Information needed based on EPA/UEC conference call on Tuesday ,
September 25, 2012.

From: Harry Anthony [hanthony@uraniumenergy.com]
Sent: 07/13/2012 09:54 PM GMT
To: William Honker; Sam Coleman; Charles Maquire <charles.maquire@tceq.texas.gov>; Ann Codrington
Cc: Andy Barrett <andy@thebarrettfirm.com>; Ben Klein <klein@heatherpodesta.com>
Subject: Final Technical information for Goliad Aquifer Exemption

Cross Section A – A'

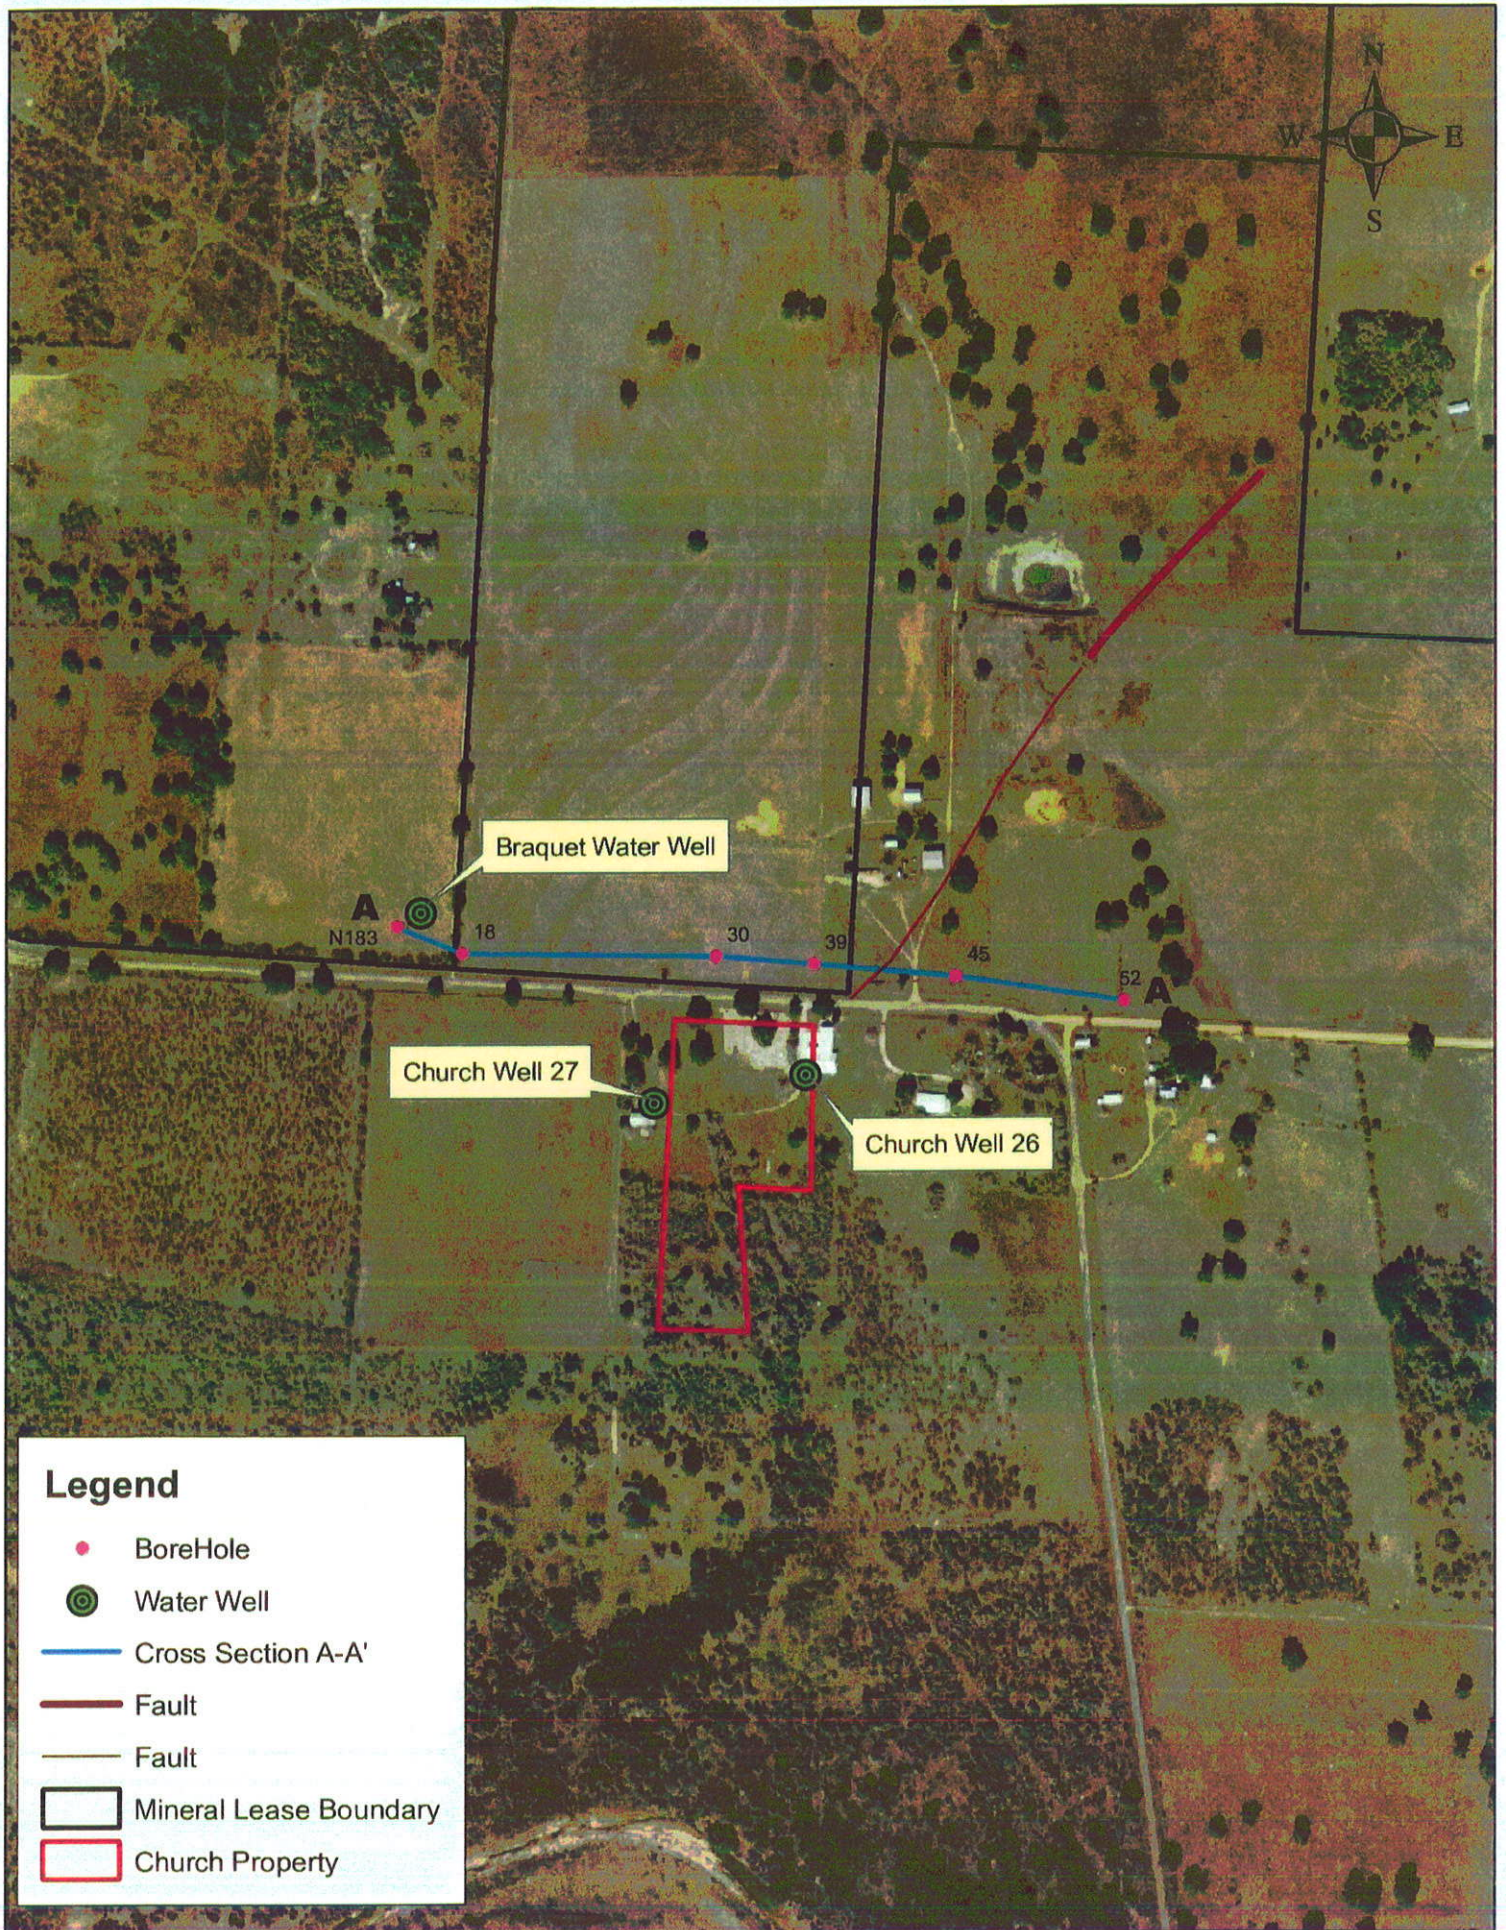
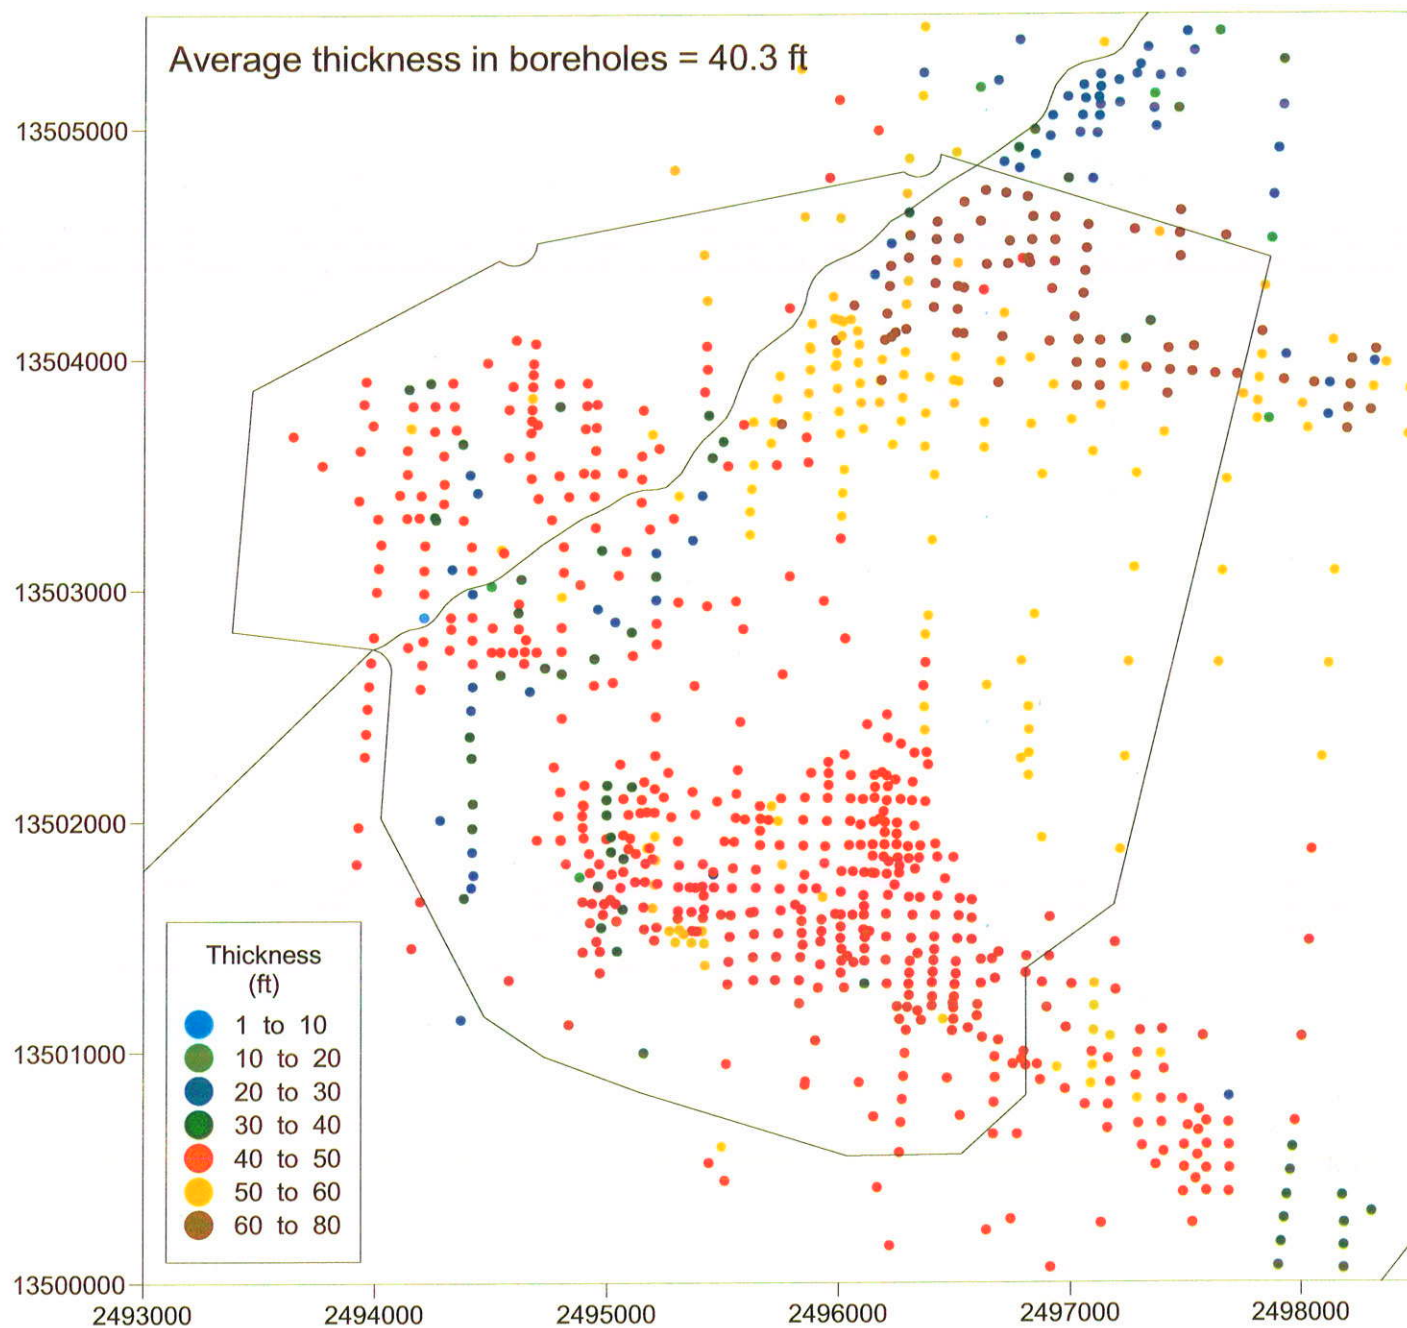
C. Please provide the date for the A -A' south fault cross sections . I assume the cross sections were based on data from a previous year (include both the date of data and a date of generation for this cross section). Email from Harry Anthony to Stacey Dwyer , et. al on Sept.14, 2012.

February 2012 B-Sand (graben wells) Water Levels

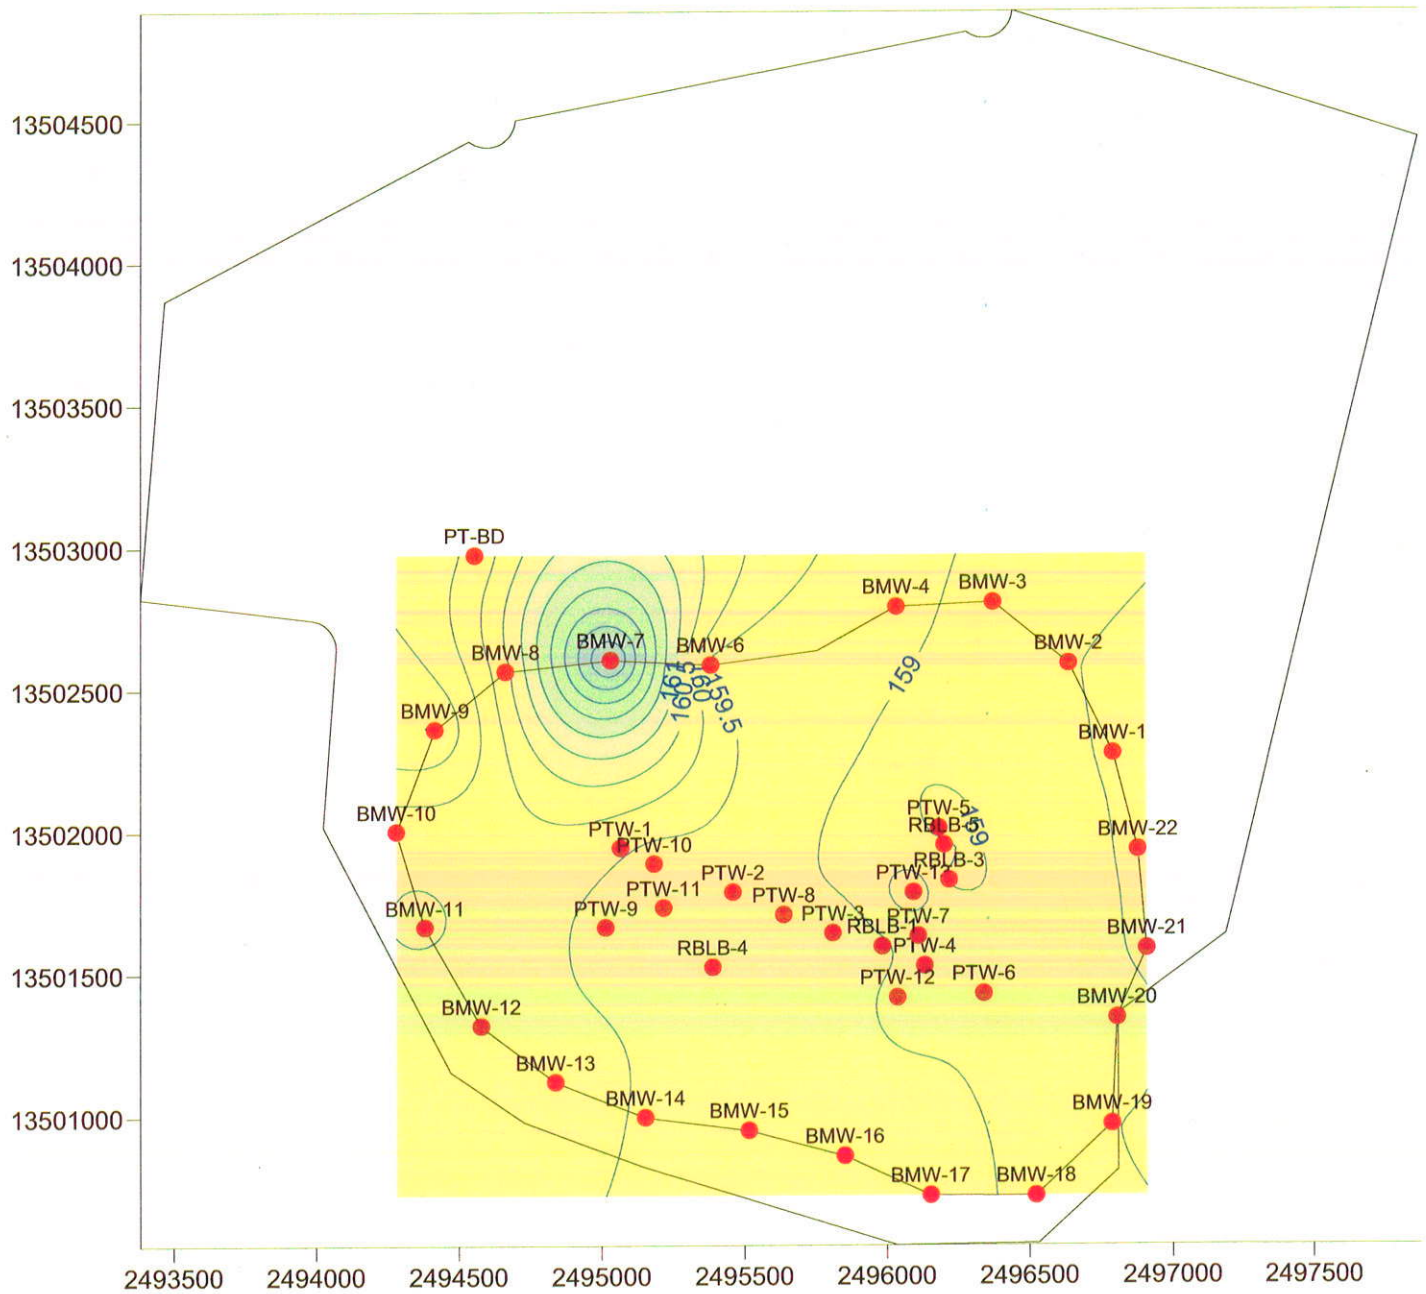
D. See email from Harry Anthony to William Honker , et. al. The first file (labeled Goliad Clay Thk and Hydraulic Gradient Details West to East), page 4 has a graphic titled "February 2012 B-sand (graben wells) Water Levels.

Question/Issue: The contours do not exactly match the data that was submitted to EPA in the Summary Table (See item B above in this email). Please ensure that all the data that is in this graphic for

February 2012 is reflected in the Summary Table .
